Report of Dam Safety Assessment of Coal Combustion
Surface Impoundments
NRG Energy
Huntley Generating Station
Tonawanda, NY

AMEC Project No. 3-2106-0194

September 2011

**APPENDIX E
DRAWING C-34738**

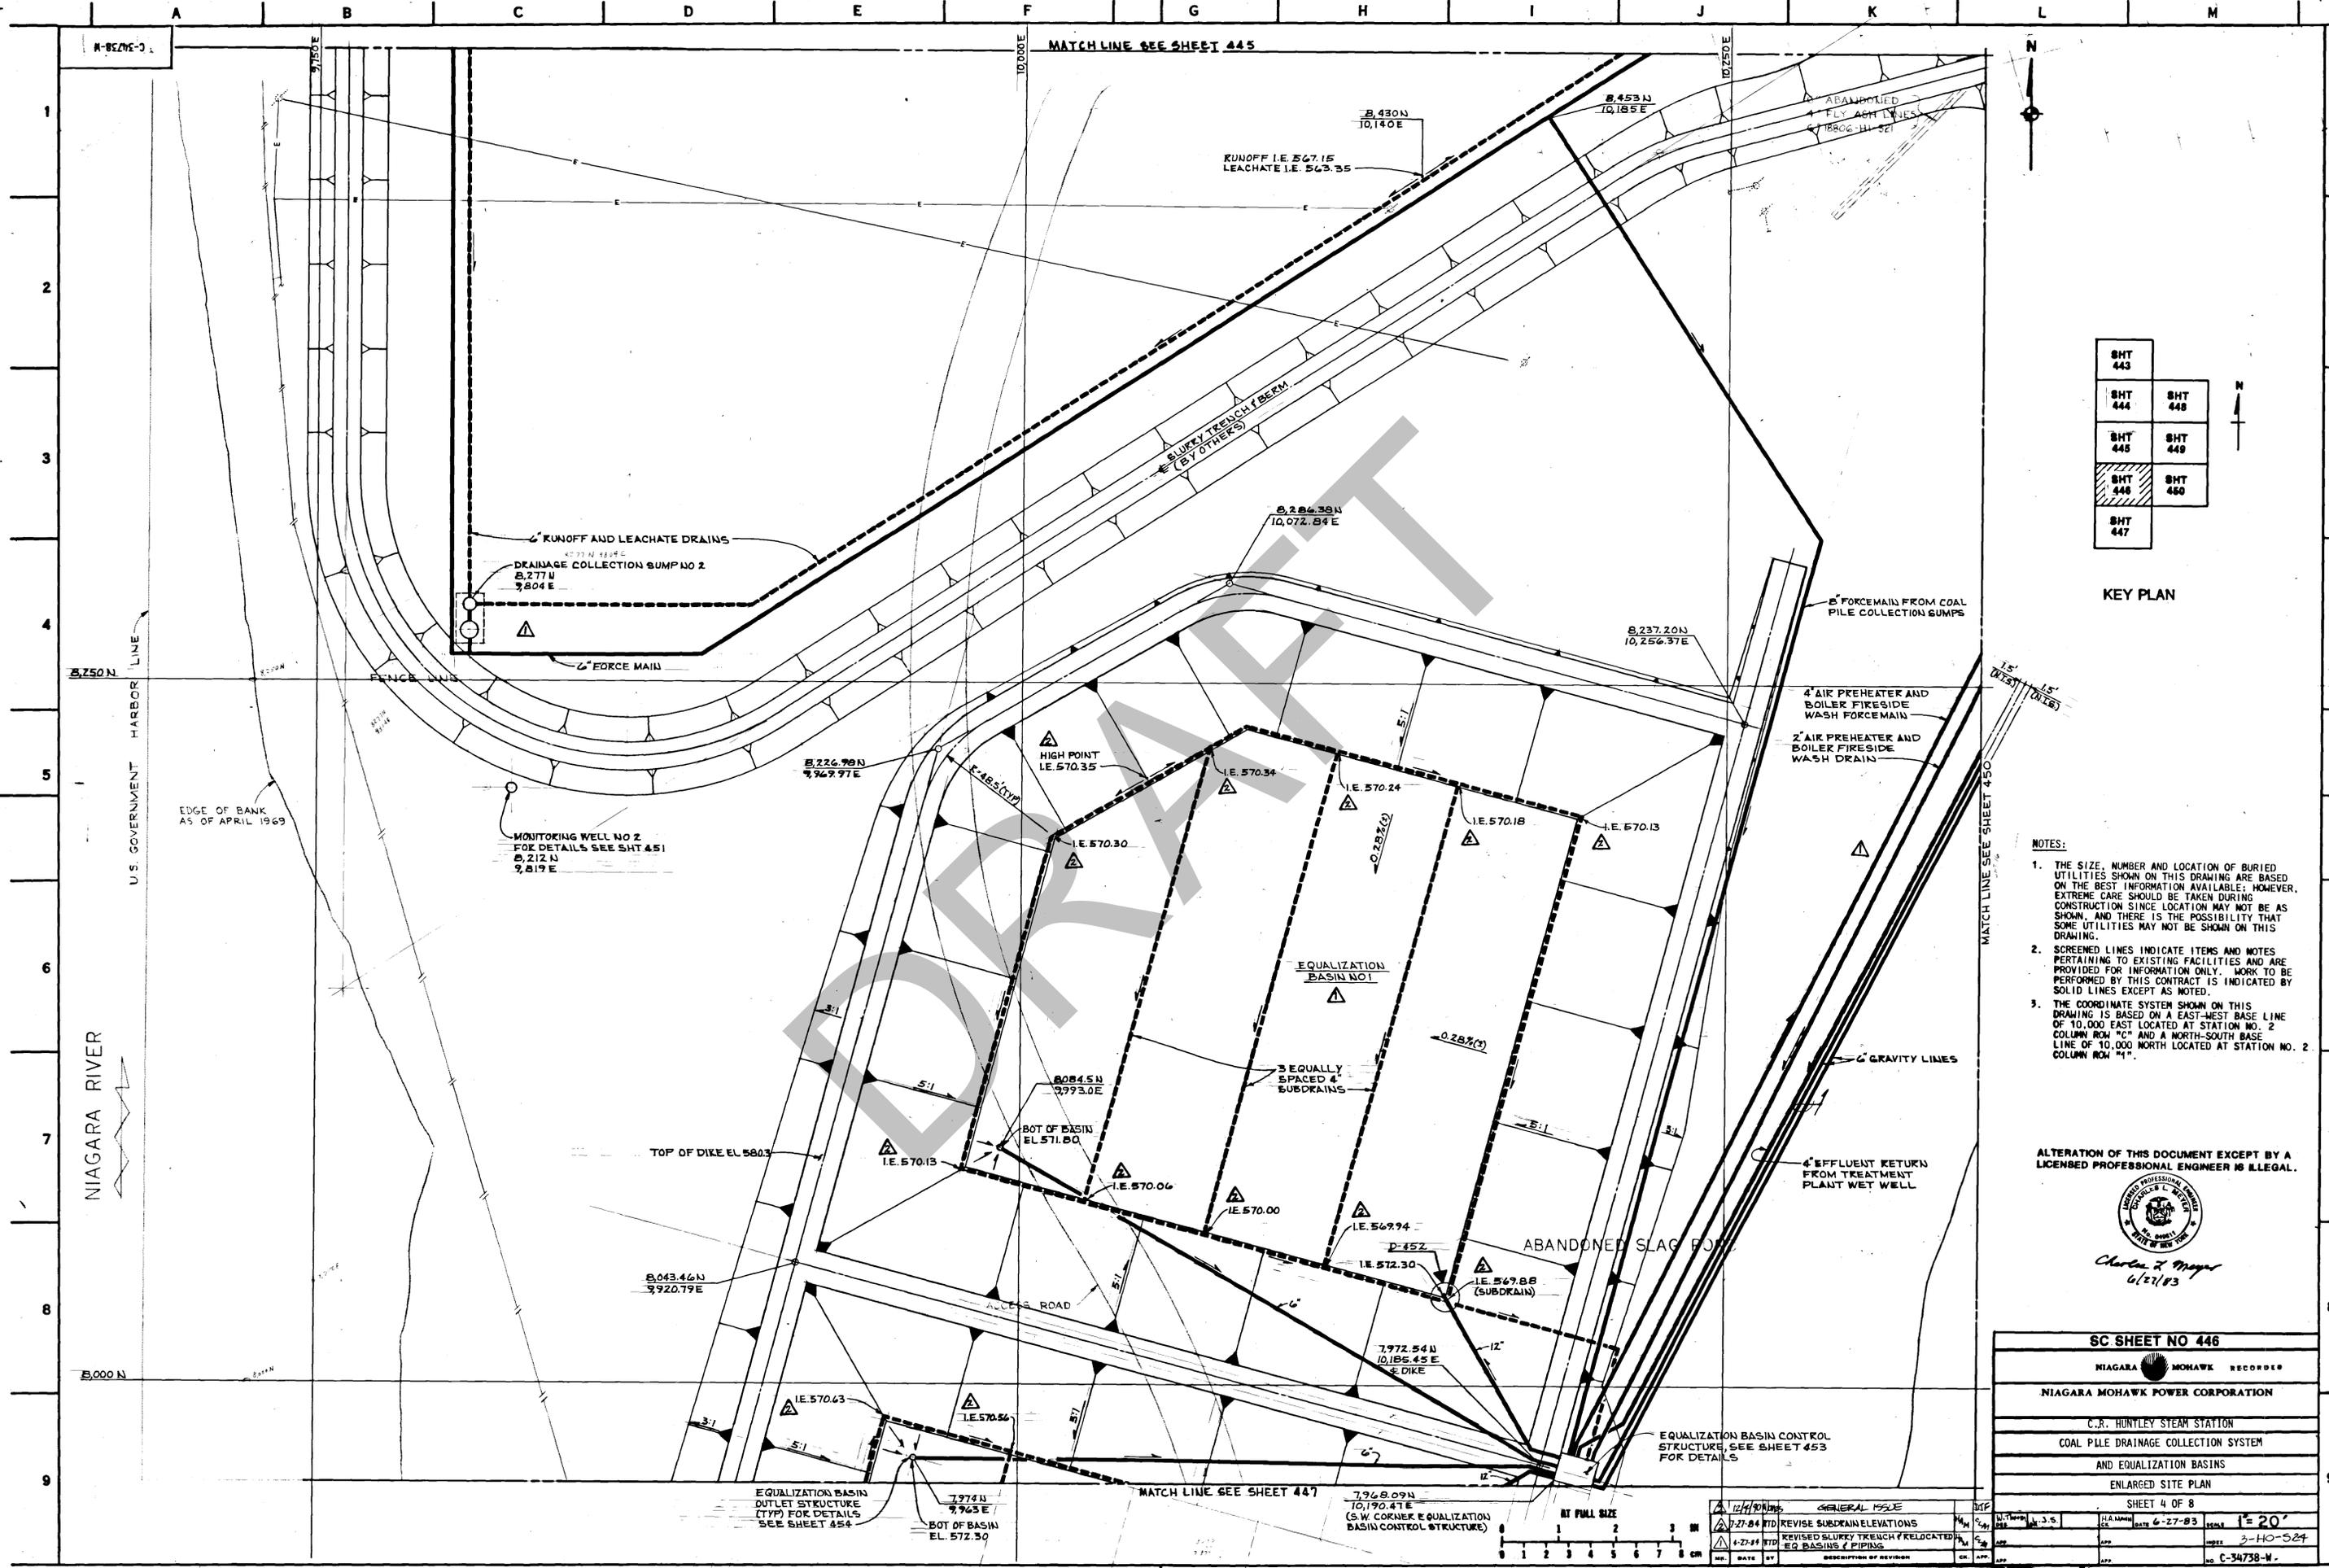
One of the provided plans for the construction of the North and South Equalization Basins, Sheet C-34738, indicate an unknown area of the coal pile and basin(s) are located within an "Abandoned Slag Pond" (shown in lower right of drawing). This drawing is presented in Appendix E. No other information on this former slag pond was provided. Based on the limited provided information, there is inconclusive evidence the North and South Equalization Ponds are built over wet ash, slag or other unsuitable materials.

Drawing C-34738 shows an "Abandoned Slag Pond" in the area of the North and South Equalization Basins (and coal pile). No other information on this former slag pond was provided. The removal or presence of this material should be confirmed with documentation or exploration. If present, the extent and effects of the slag material on the stability of the embankments should be analyzed.
